CO-OP MINING COMPANY
P.O. Box 300
Huntington, Utah 84528

UMC 784.14 Reclamation Plan: Hydrologic Balance

MODIFICATION DEFICIENCIES

RE: Scalehouse Modification
Final Approval
Bear Creek Canyon Mine
ACT/015/025
Folder Nos. 3, 4 and 7
Emery County, Utah

FIGURE
NO. 1

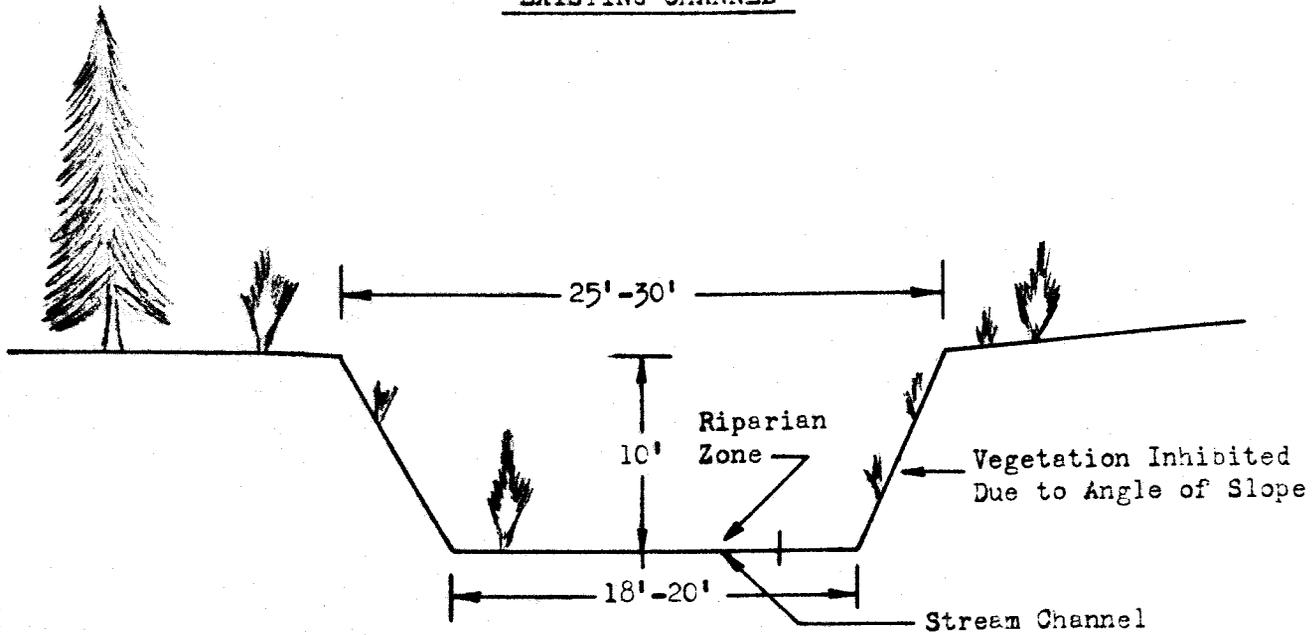
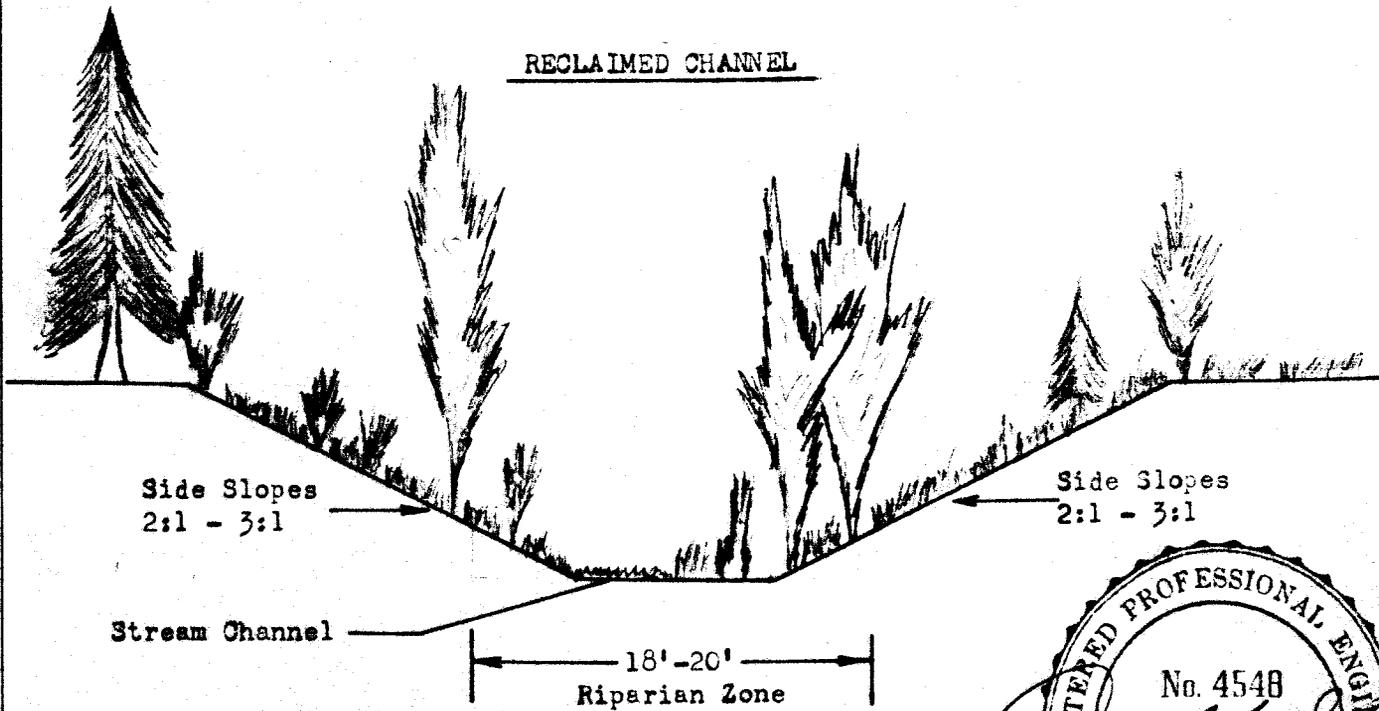
The applicant has not completely addressed this requirement. The applicant has not provided maps, plans and cross-sections to depict postmining drainage patterns. Clarification of a statement in the MRP regarding "horizontal drainage patterns," a postmining drainage map, cross-sections depicting postmining topography and drainage, specific measures for stabilizing reclaimed drainage channels and details on measures proposed for reclamation of the main stream channel where it is currently culverted were not submitted as required. The previous MRP had proposed a log check dam configuration for reclaiming the Bear Canyon stream channel. This proposal was removed by the April 30, 1984 response and the only inference to reclaiming the stream channel is the depiction of eight-inch riprap shown on Plate 3-2.

1. To use a large track mounted excavator in conjunction with a small backhoe and crawler tractor to remove the 60' culvert and to regrade the opposing banks on approximately a 3 to 1 slope to facilitate revegetation and to enhance the establishment of a riparian zone. (Note fig. 1 for the present stream configuration and projected after reclamation).

FIGURE
NO. 2

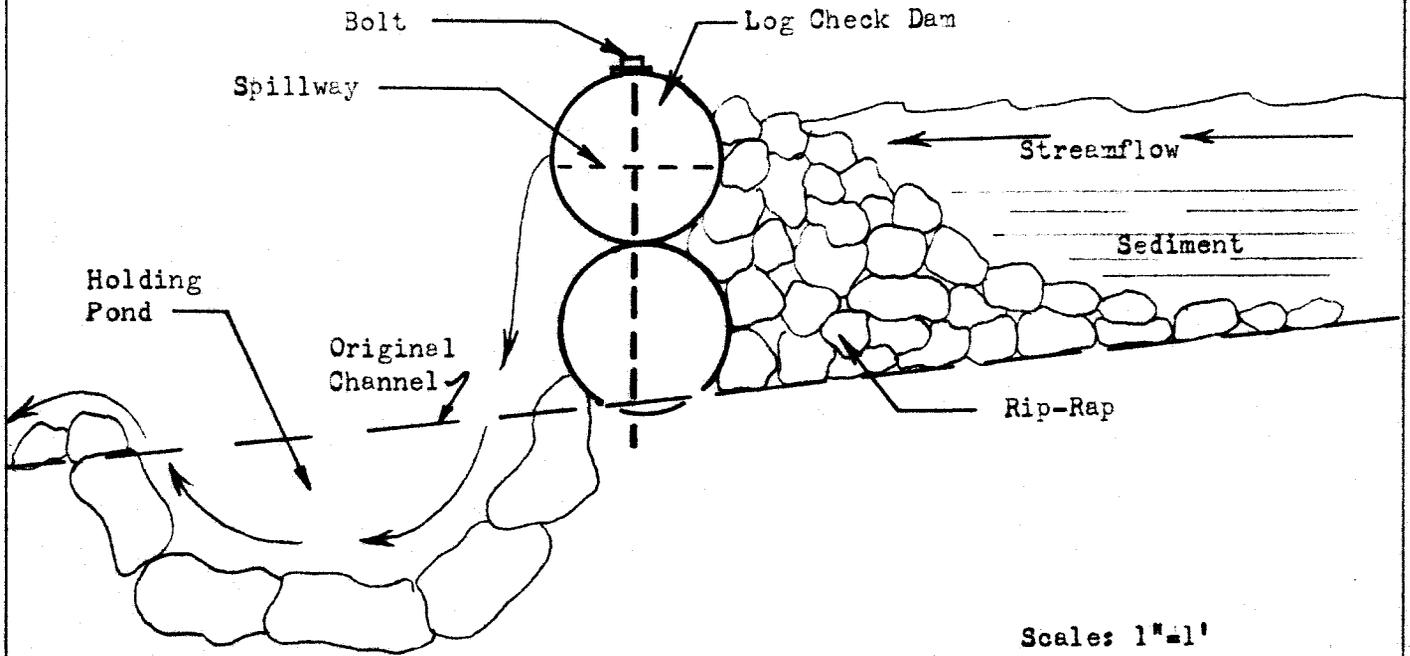
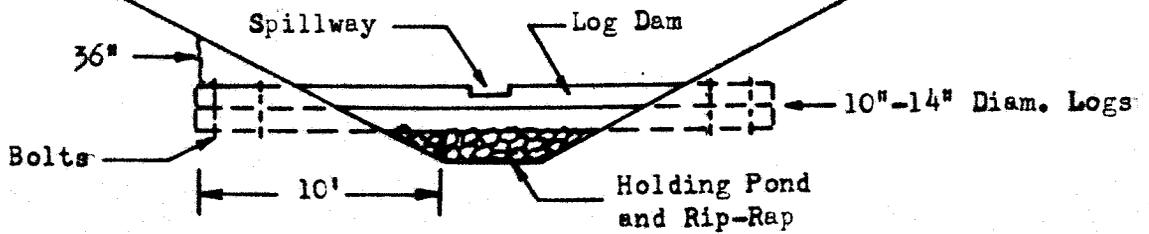
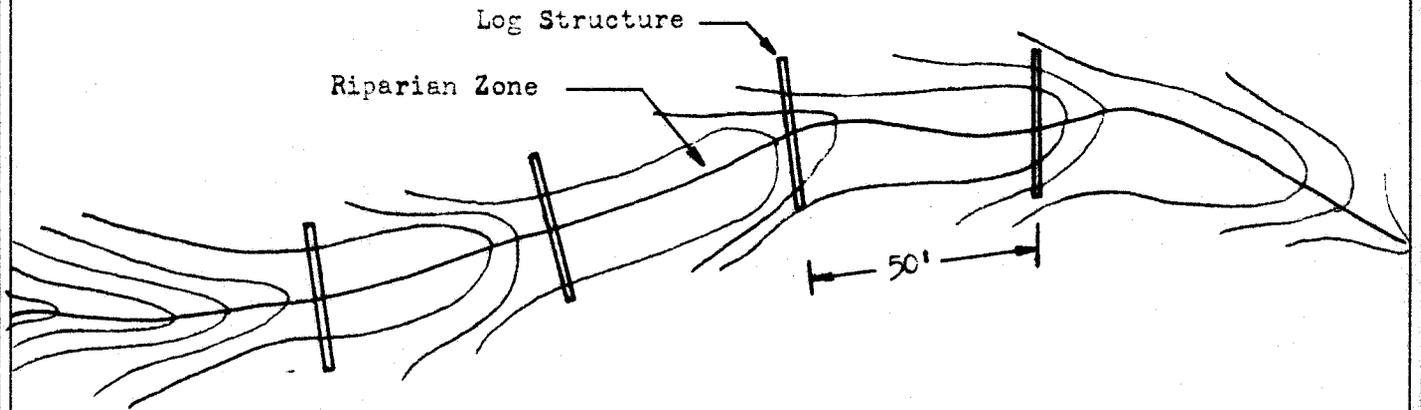
UMC 817.44 Hydrologic Balance: Stream Channel Diversions

2. To construct small holding ponds along the channel utilizing native materials. The actual methodology is to incorporate 2 logs approximately 10 to 14" in diameter, trench into the bank back approximately 10' on both sides of the creek channel, secure the logs together in a stacked manner with 3/4" anchor bolts, buried for approximately 10 feet with approximately 36" of fill material decreasing to 0" as the stream channel is approached. An 18" wide by 5" deep notch cut along the top of the upper log in the center of the creek channel, to create a centralized spill-way. Once the logs are secured into the channel, rock rip-rap should be laid on the up stream side to a height equal to the height of the log retainer and continued up stream for a distance of 36" decreasing in height so as to be level with the original rip-rapped channel. Then by utilizing a backhoe, a pit approximately 3' in diameter should be dug at the fall line of the spillway and lined with large rock 2' +. The log-pond configuration should be repeated at approximately 50' intervals along the course of the creek channel to create a stepped configuration along the area of disturbance.

of this potentially detrimental source of silt and convert it into a potentially beneficial, enriched, growth media to facilitate the enlargement and establishment of riparian vegetation. Over a course of time the water holding capability of the ponded area will decrease as the ponds fill with sediment, however, the small ponds at the base of the spillway should remain relatively free from sediment and due to the small surface areas and depth, they will hold water over an extended period during dry seasons. A diagram is attached for your review. (See fig. 2).

FIGURE NO. 1

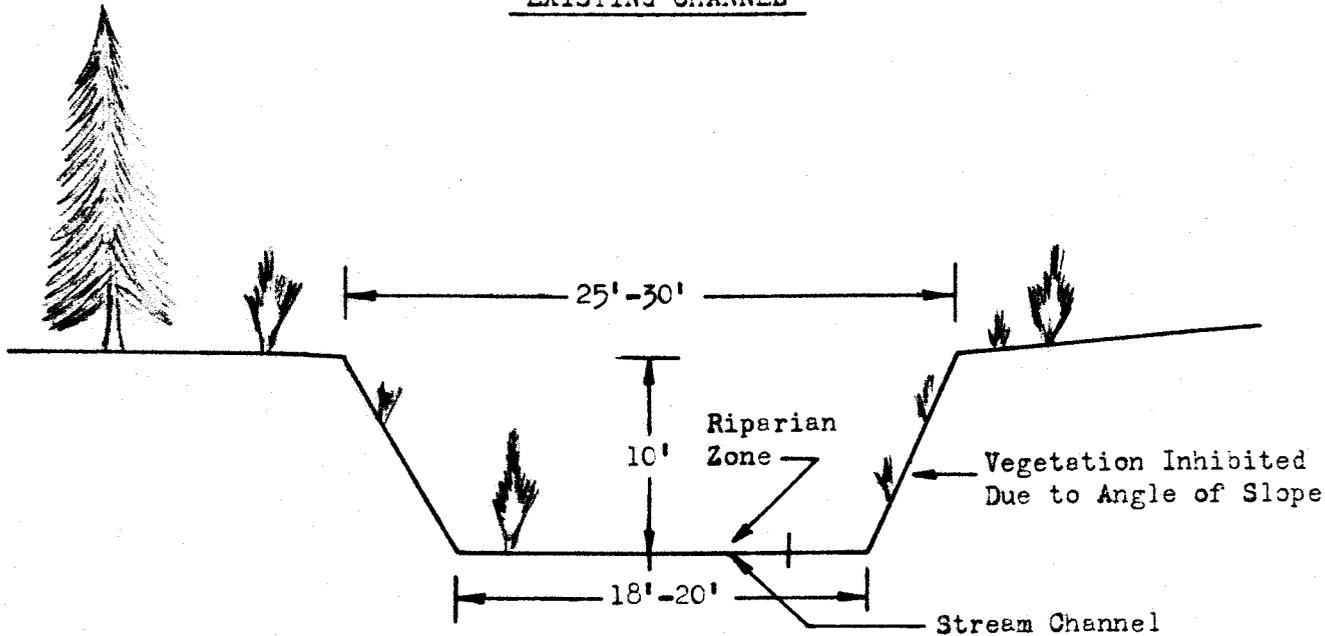
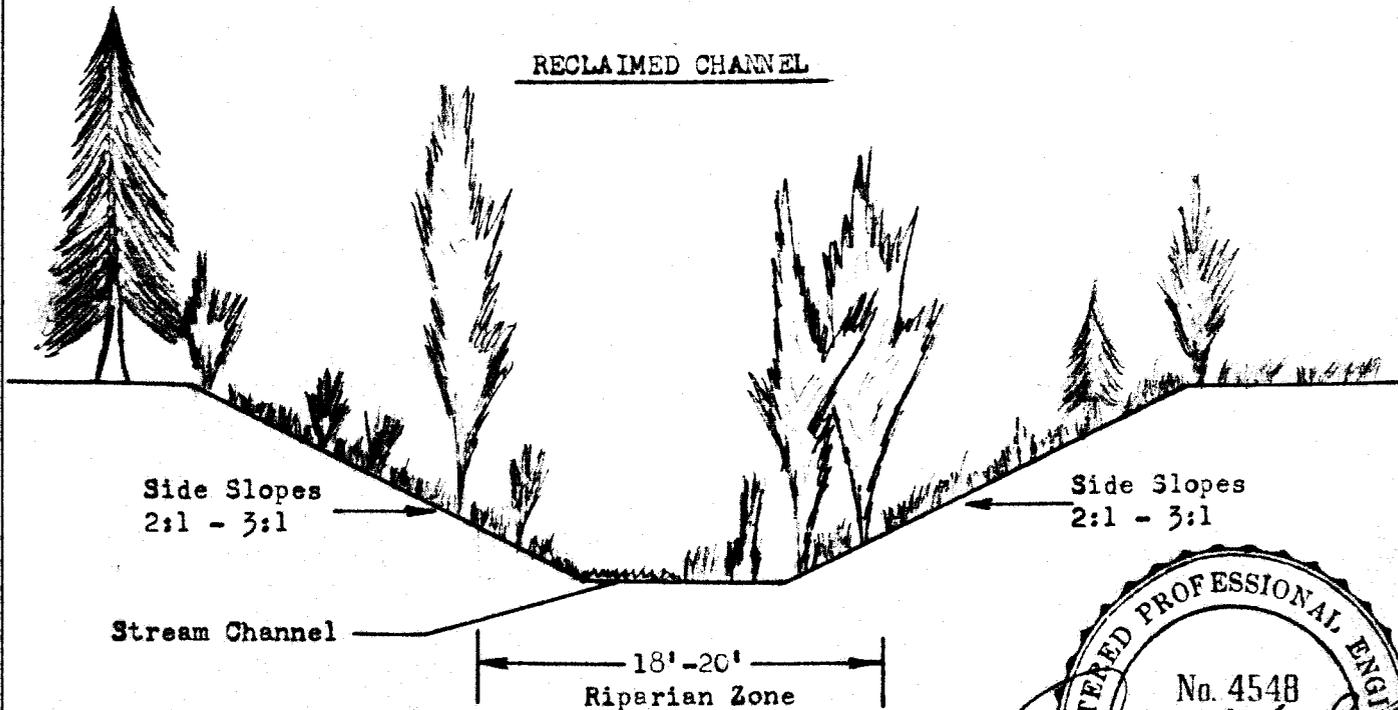
The applicant has not completely addressed this requirement. The applicant has not provided maps, plans and cross-sections to depict postmining drainage patterns. Clarification of a statement in the MRP regarding "horizontal drainage patterns," a postmining drainage map, cross-sections depicting postmining topography and drainage, specific measures for stabilizing reclaimed drainage channels and details on measures proposed for reclamation of the main stream channel where it is currently culverted were not submitted as required. The previous MRP had proposed a log check dam configuration for reclaiming the Bear Canyon stream channel. This proposal was removed by the April 30, 1984 response and the only inference to reclaiming the stream channel is the depiction of eight-inch riprap shown on Plate 3-2.

1. To use a large track mounted excavator in conjunction with a small backhoe and crawler tractor to remove the 60' culvert and to regrade the opposing banks on approximately a 3 to 1 slope to facilitate revegetation and to enhance the establishment of a riparian zone. (Note fig. 1 for the present stream configuration and projected after reclamation).

FIGURE
NO. 2

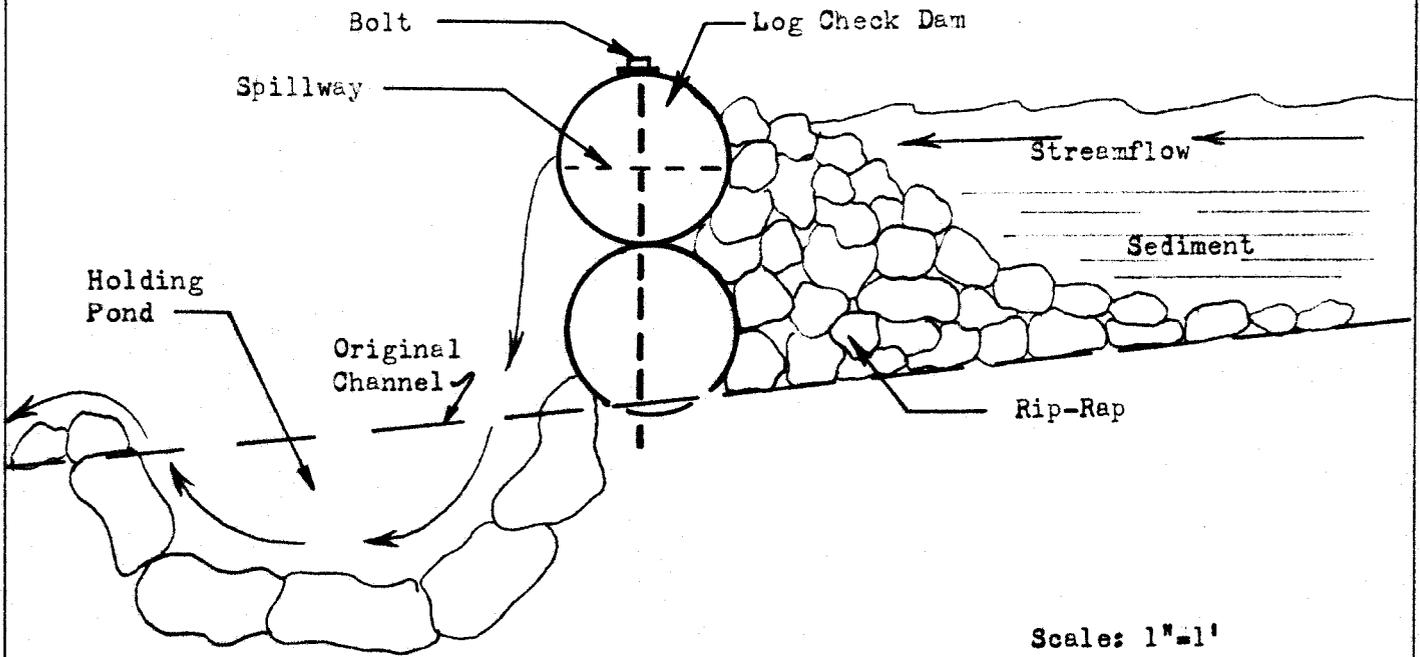
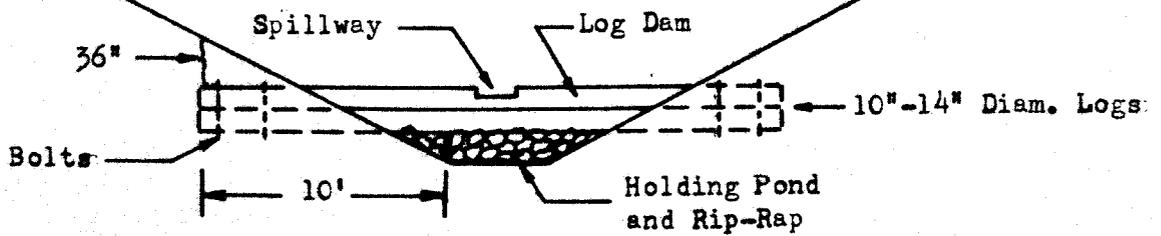
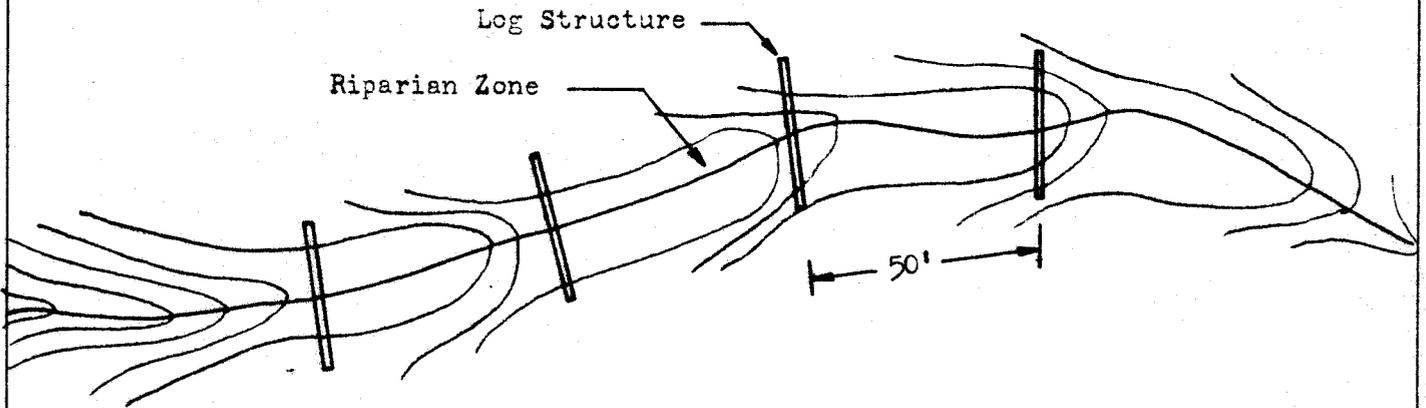
The applicant has not completely addressed this requirement. Cross-sections of disturbed and undisturbed ditches have not been submitted. Cross-sections of the Bear Canyon stream channel were not certified prior to the March 1984 DOC/TD document. The April 30th response omitted not only the certification but also the original cross-sections.
